FOOTING SLAB - F3A - BILL OF MATERIALS / EMBEDS

Following documents and/or sources:	STATE AGENCY VTTrans	G.W. TATRO CONSTRUCTION, INC. VT/AOT BRIDGE REPLACEMENT - ROAD IMPROVEMENT RICHFORD, VT.
PROJECT, TOWN OF RICHFORD	Concrete Systems Inc. 9 Commercial St., Hudson, NH, 03051 Phone 603-889-4163 Fax 603-889-2417	SHOP DRAWING F3A C22312-F3A
DATED 2011	Drawn By: R. YEAGER Reviewed By: B. KOLAWOLE Approved By: C. VICK	REV 1
	Date: 16APR2015 Date: 17JUN2015	Quantity: 1 Project No: BRFO30229 SHEET 11 OF 14

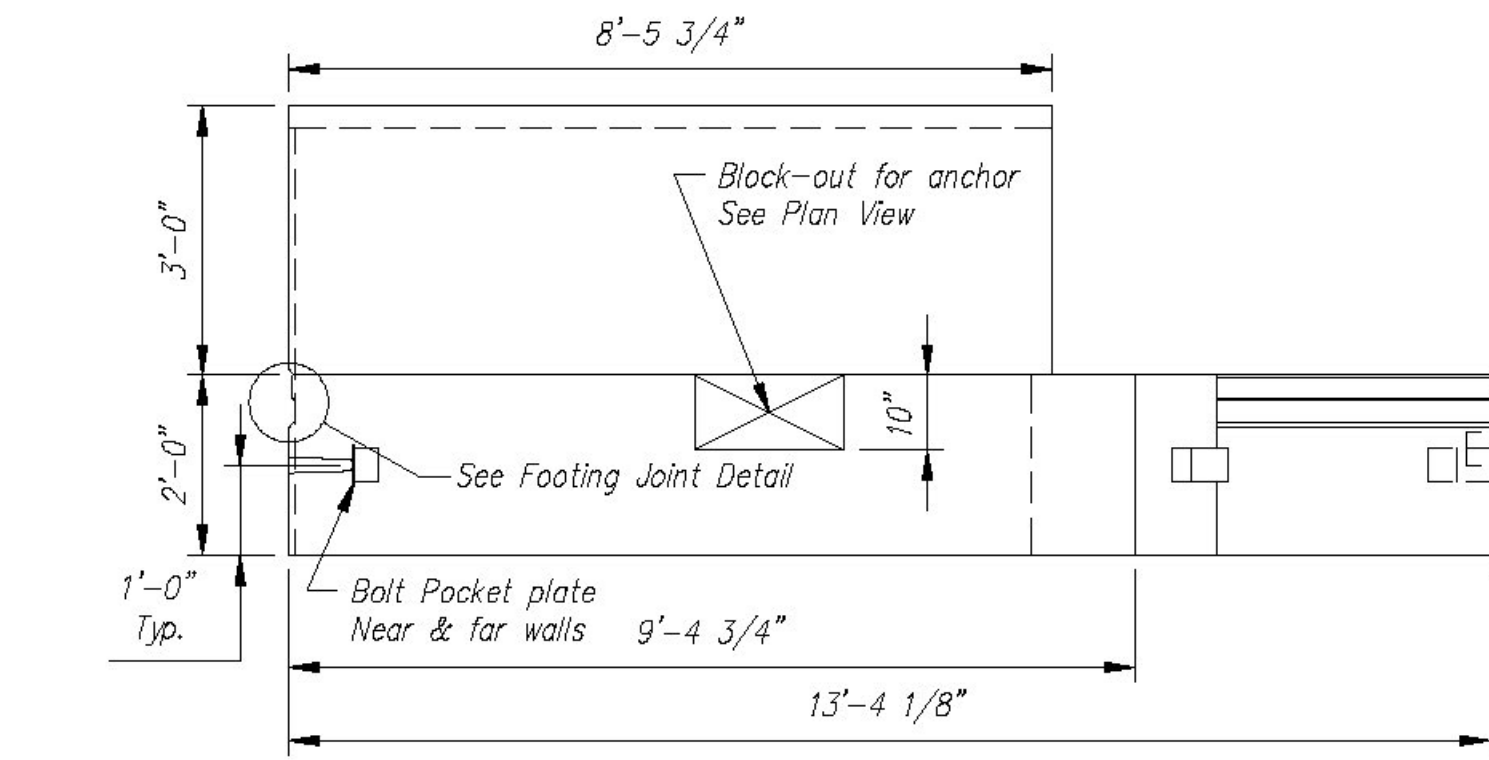
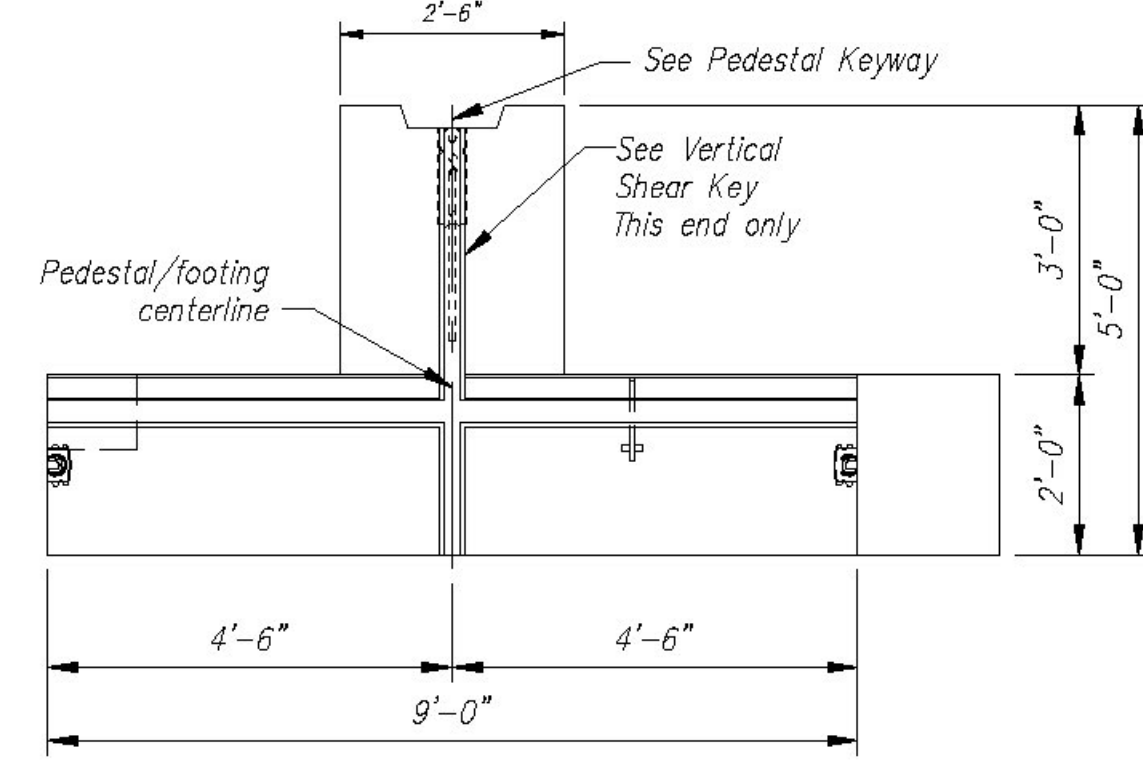
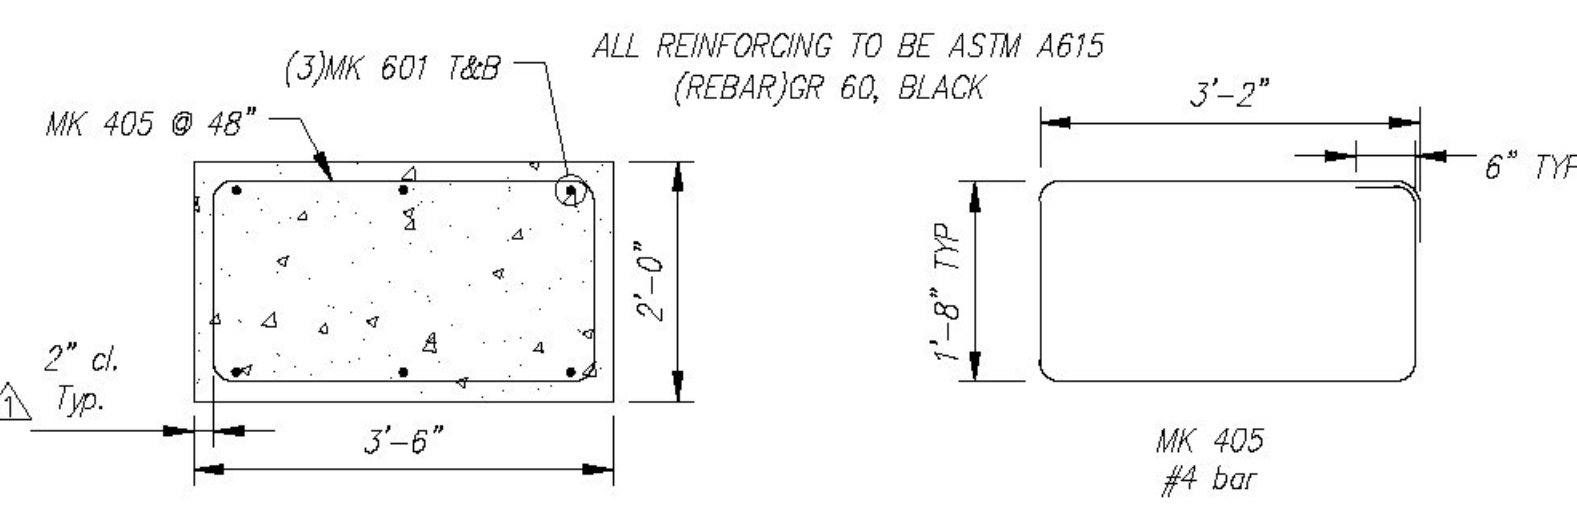
REV.	DESCRIPTION	DATE
10		
9		
8		
7		
6		
5		
4		
3		
2		
1	REVISED PER CUSTOMER REVIEW, ADDED BOLT POCKETS, REVISED ANCHOR LOCATIONS	14MAY2015

Vermont Agency of Transportation
RECEIVED
CK'D BY CLB OK'D BY HIS
July 22, 2015
RESUBMIT NO Approved
BY C. CARLSON DATE 07/23/15
